CITY OF OREGON CITY HISTORIC REVIEW BOARD (HRB) AGENDA

2. Recommendation of Adoption of the Design Guidelines for New Construction- Middle Housing to the City Commission
3. New Construction of a Tri-Plex on Land that is Part of a Designated Landmark - Rasmussen-Buol House (151 Molalla Avenue) (GLUA-23-00001; HR 23-00002)

**PRESERVATION GRANT REQUEST
HISTORIC REVIEW BOARD
March 20, 2023**

REVIEWER: Christina Robertson-Gardiner, AICP Senior Planner

A6

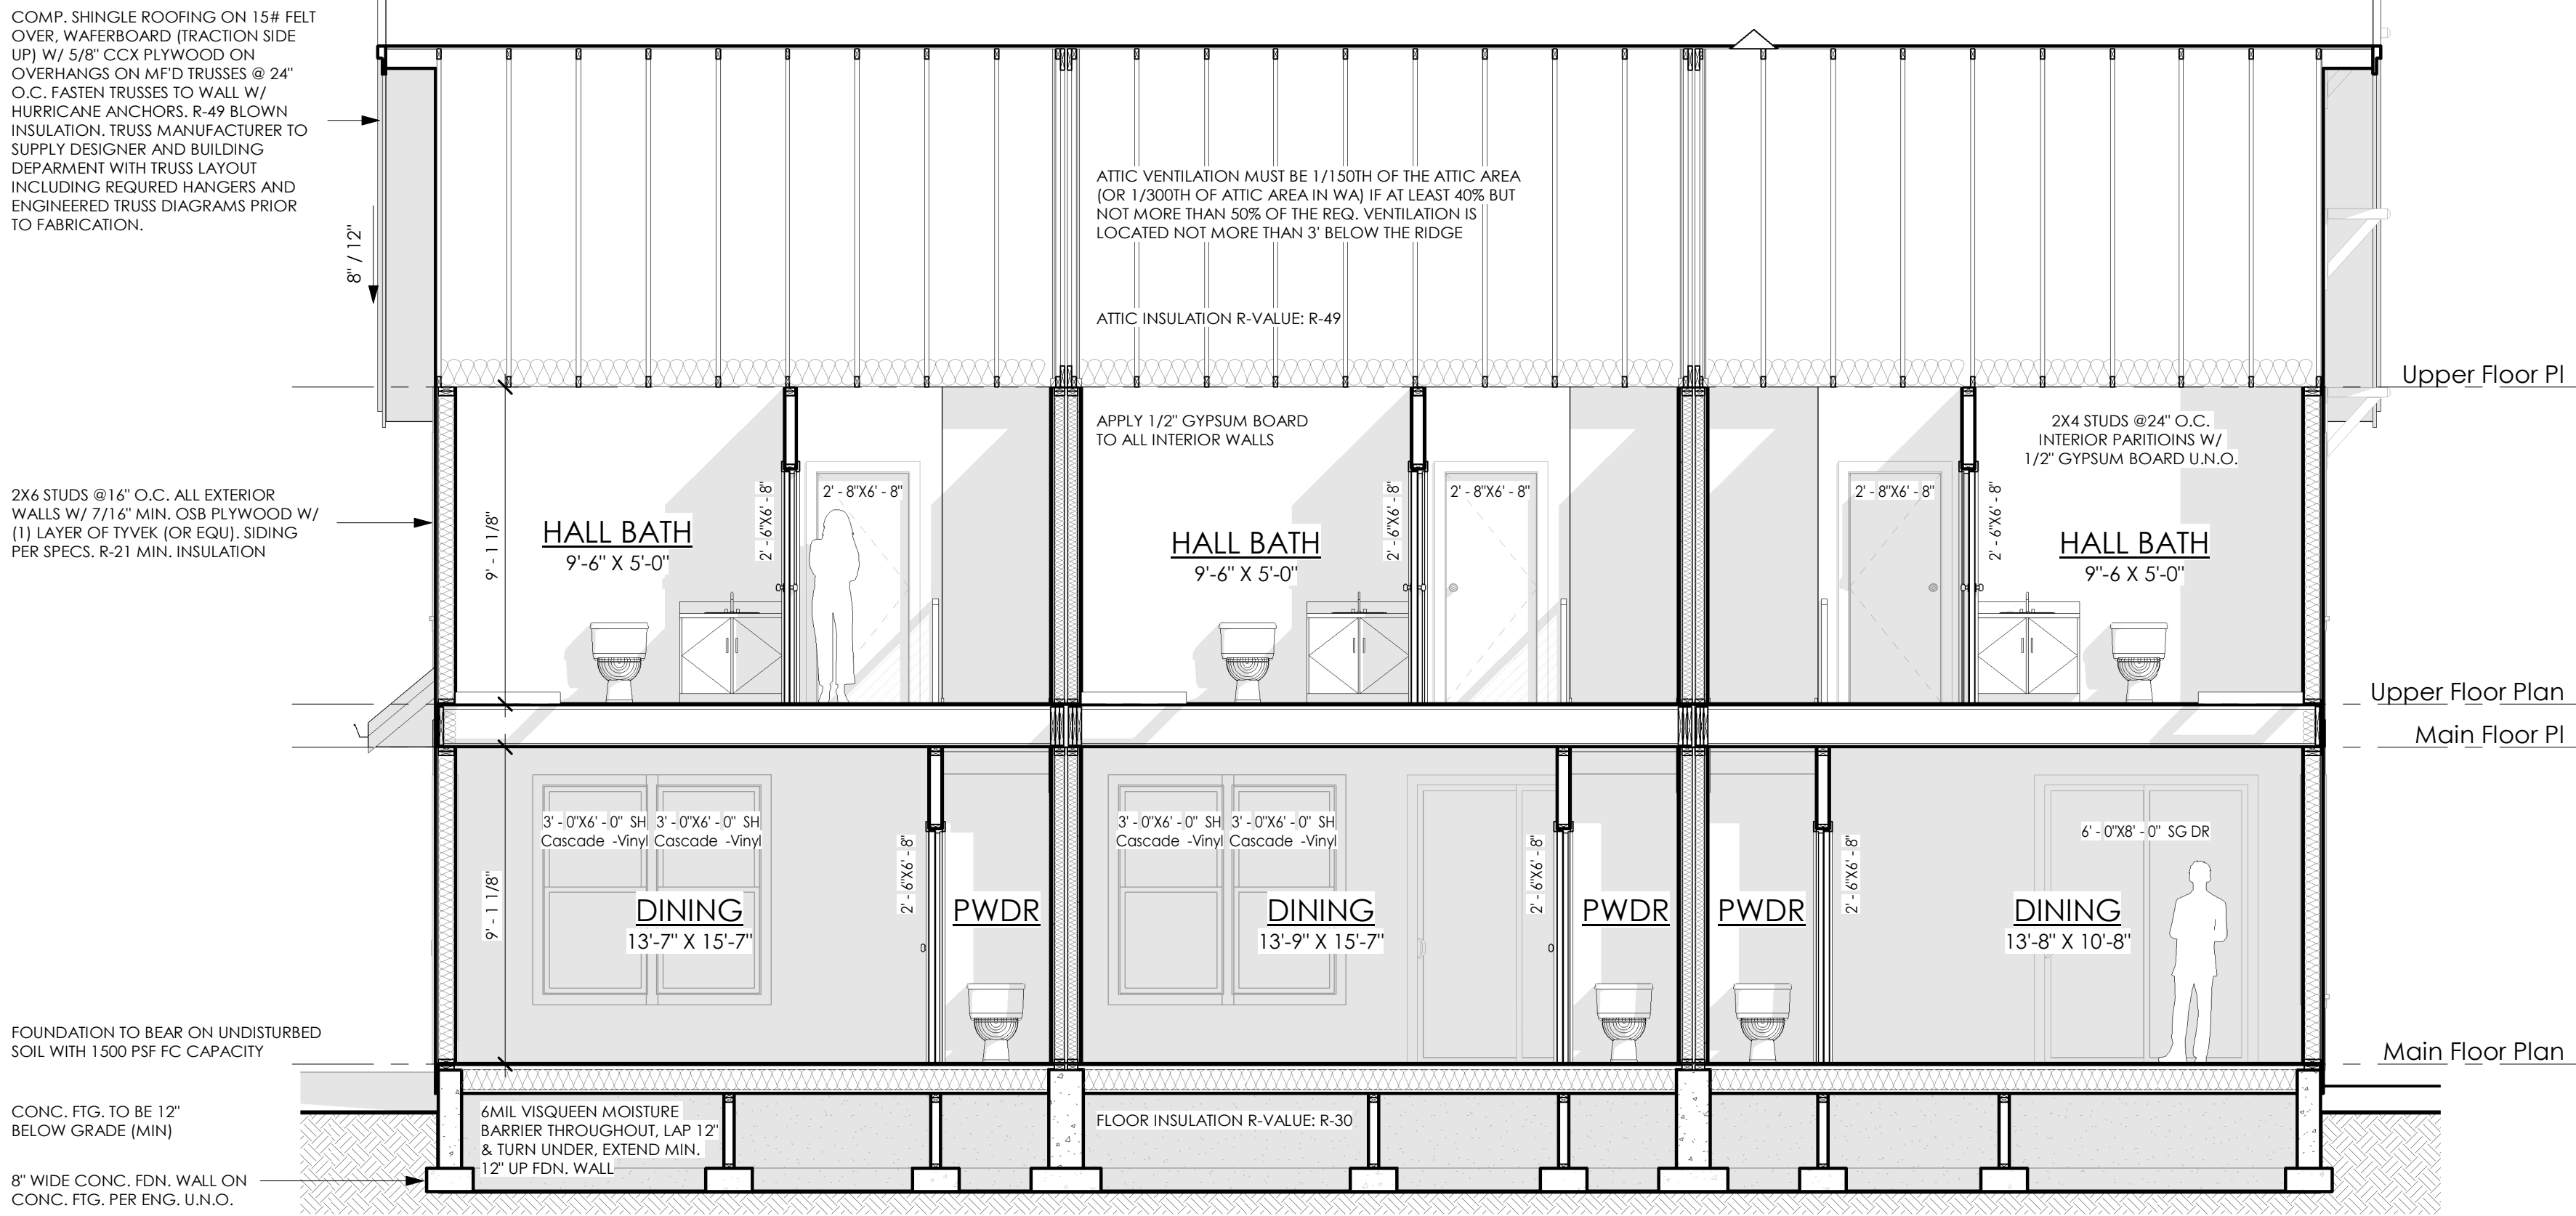
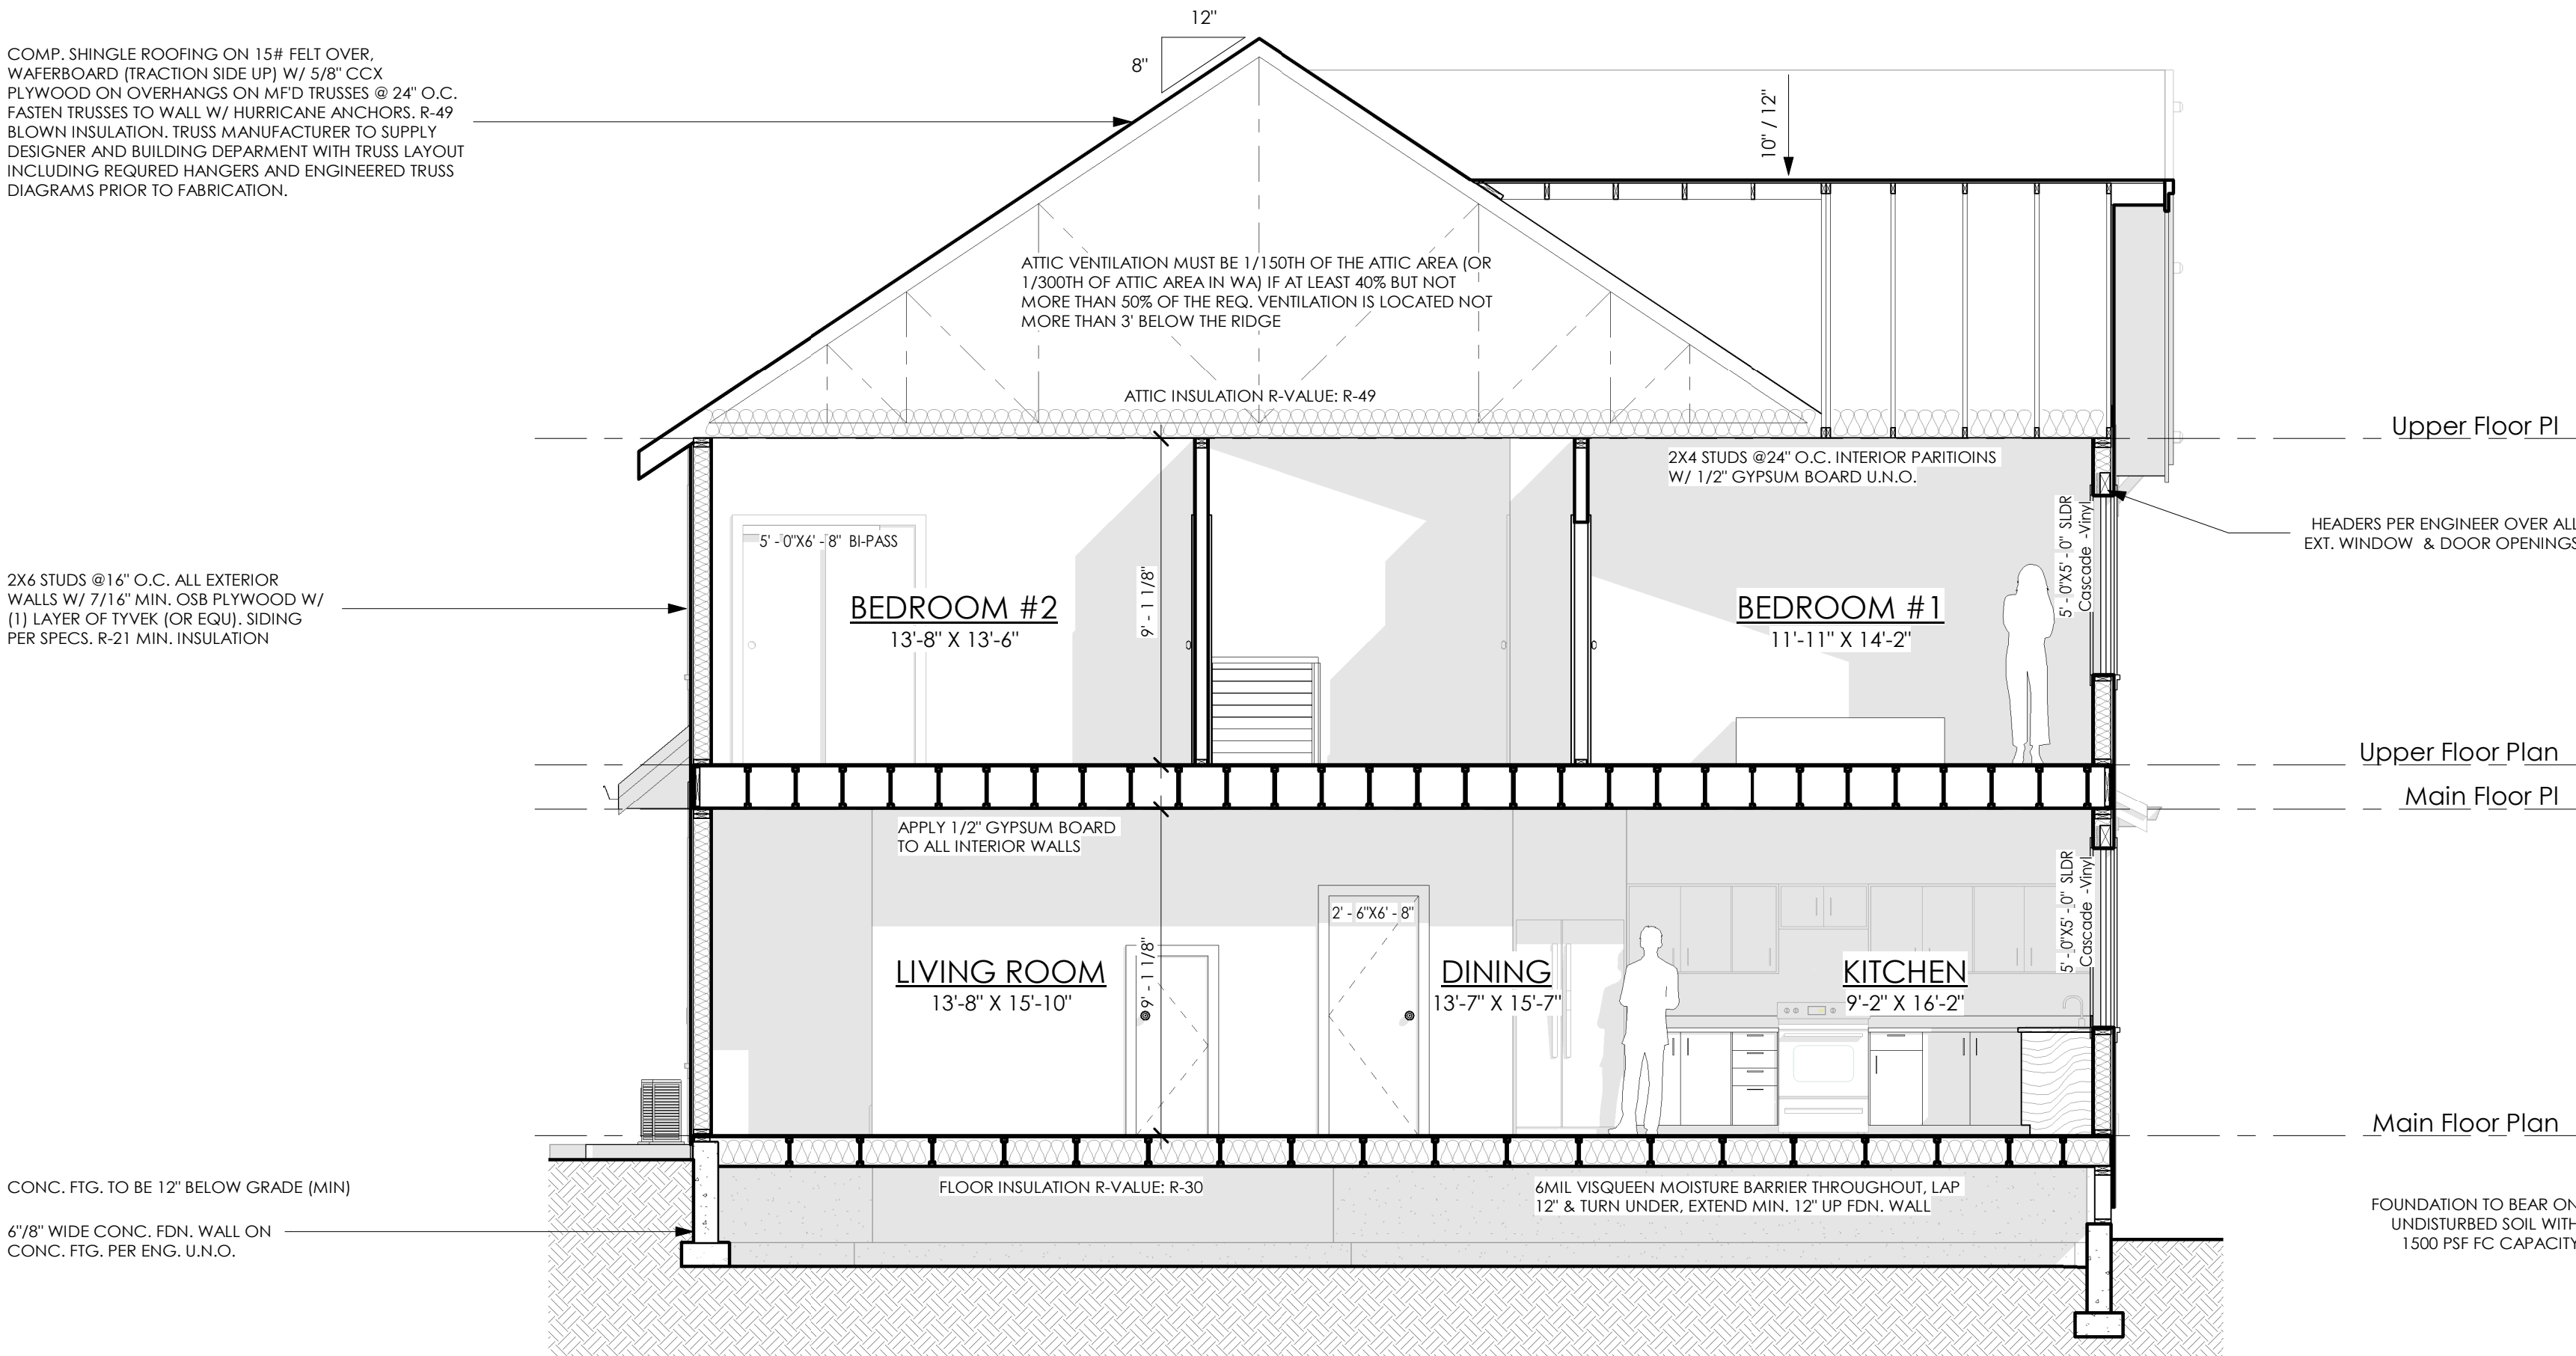
Please note that the stair design from the specification (Sheet A6) below does not match the 3rd rendering showing horizontal railings.

- d. The porch design shall align with the specification found in sheet A6.
 - e. Corner trim shall be utilized on the building.
 - f. Porch railing, decking, and posts shall be painted to match the color scheme of the house.
